Access Compliance Report Public Rights-of-Way (Curb Ramps)

Main Street: CHAPMAN_AVE		Cross Street: NEARING_DR		Location:	NW
ADA ID: RPAT211130120058	Ramp Type: Type 4 - Parallel	Initial Pass/Fail: Fail	Overall Compliance: No	Severity Score:	15
Codes/Mitigation Info/Possible Solution			Field Measurements/Component Compliance

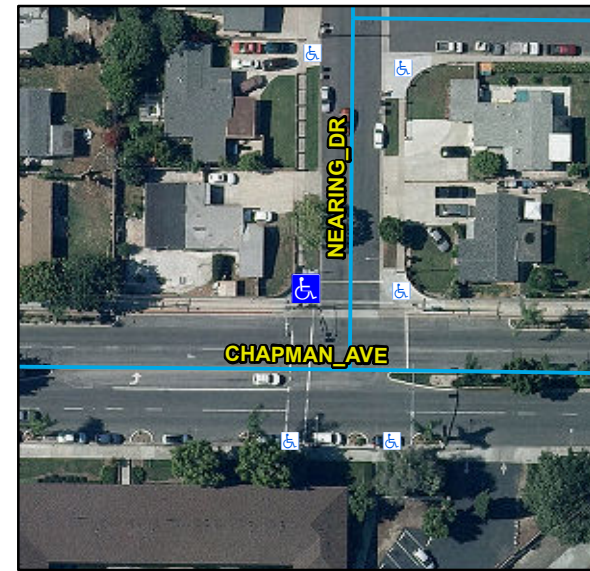
R304.2.2, R304.5.3, STD 1115

Remove & Replace Curb Ramp With Two New Directional Ramps or Equivalent.
